**Name of Proposal:** Lithia Springs Data Center DRI 4326

A DRI review of a proposal to construct a data center with a total of 1,302,176 SF of space in 4 buildings along with an electrical substation and supporting facilities on a 81.7-acre site at the intersection of Thornton Road and Factory Shoals Road in Douglas County.

**LITHIA SPRINGS DATA CENTER PHASE II DRI**  
**Douglas County**  
**Natural Resources Review Comments**  
**March 11, 2025**

*DRI Comments of March 12, 2025*

PROJECT DELIVERY PACKAGE  
SUP/REZONING SITE PLAN

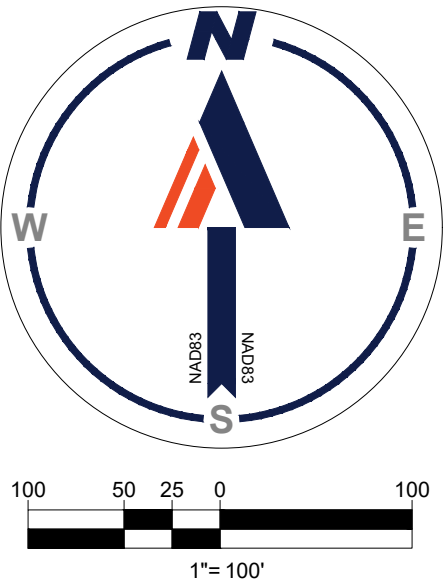
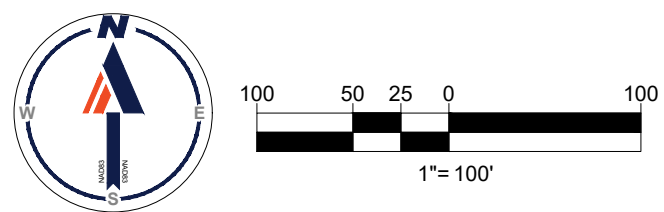
The USGS coverage for the project area and the submitted site plan both show a blue-line branch of an unnamed tributary to Sweetwater Creek with headwaters starting in the southwestern corner of the project property and flowing to the west. The project is within the Douglas County Sweetwater Creek/ East Point Intake Basin subwatershed, with the basic requirement of a 150-foot impervious surface setback and a 100-foot undisturbed buffer on all streams but allows for 25% reductions to a 112.5-foot impervious setback and a 75-foot undisturbed buffer with an administrative variance. The submitted site plan shows the 112.5-foot impervious setback and a 75-foot undisturbed buffer, both noting the 25% reduction through administrative variances. The 25-foot State Sediment and Erosion Control buffer is also shown. No buffer or setback intrusions are shown for the portion of the project under review.
